**PLANNING COMMISSION  
STAFF REPORT**

Case No. 01P-26-01-SP

***Location:*** 604 Moores Mill Road

- Site Plan approval for construction of a 1,246 square-foot two-story addition to the existing Business Support Service use.
- Landscape Plan approval for the project.

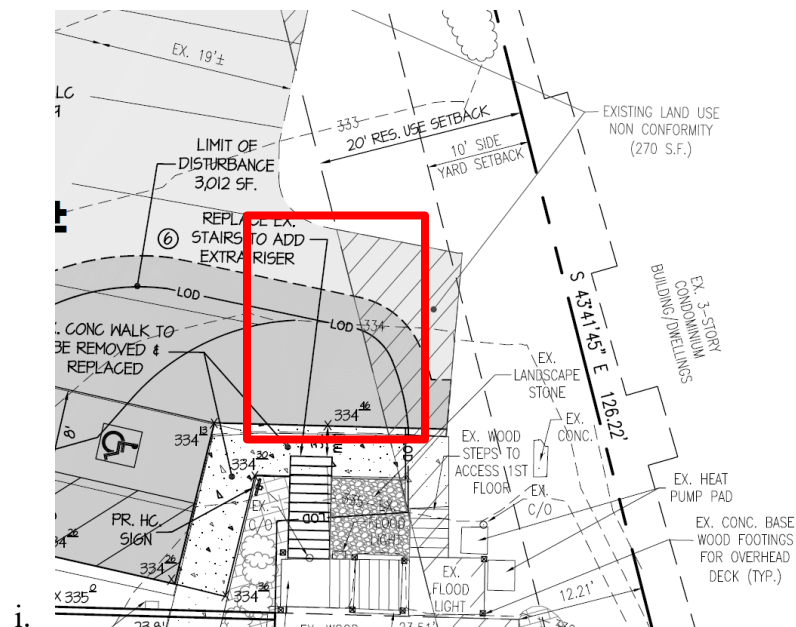
Please address the following at the hearing:

1. Two shed structures currently encroach onto the 604 Moores Mill Road property from 801 Conowingo Road (Del Haven Service Station) and 608–610 Moores Mill Road (Moores Mill Crossing). An easement or license granting access rights to the adjacent

property owners is required. If the adjacent property owners intend to relocate their respective sheds, this must be addressed at the hearing with the expected timeframe for their relocation.

2. Upon review of the site plan, it was noted that the impervious area labeled “Existing Land Use Non-Conformity (270 sq. ft.)” is located directly northwest of the handicapped spaces and directly north of the existing structure. This area falls within the required 20-foot residential setback specified in Town of Bel Air Code Table 165-29 for the B-1 Limited Business District.
  - a. Specify the use of the impervious surface or remove the impervious surface located directly behind the existing building and revise the notation for the “Existing Land Use Non-Conformity (270 S.F.)” to reflect an adjusted area and provide an updated description of the use for the northeastern rear parking area.

3. Provide additional information and specifications regarding the location, design, and operation of on-site refuse and recycling facilities.
4. Per Town of Bel Air Code §165-51D, all off-street parking spaces must measure nine feet in width by 18 feet in length. Upon review of the site plan, it was noted that the 12 proposed spaces on the western side of the parking lot are shown at 8.5 feet in width and 19 feet in length. Please revise the existing parking area to comply with the required off-street parking dimensions specified in §165-51D. This adjustment may reduce the total number of spaces; however, as long as a minimum of 11 spaces is provided, the project will remain in compliance with Town of Bel Air Code §165-51H.

- a. This adjustment would provide a 22-foot drive aisle directly northwest of the proposed addition and a 23-foot drive aisle along the northern rear of the site. The 23-foot aisle width must be expanded to 24'-0”.
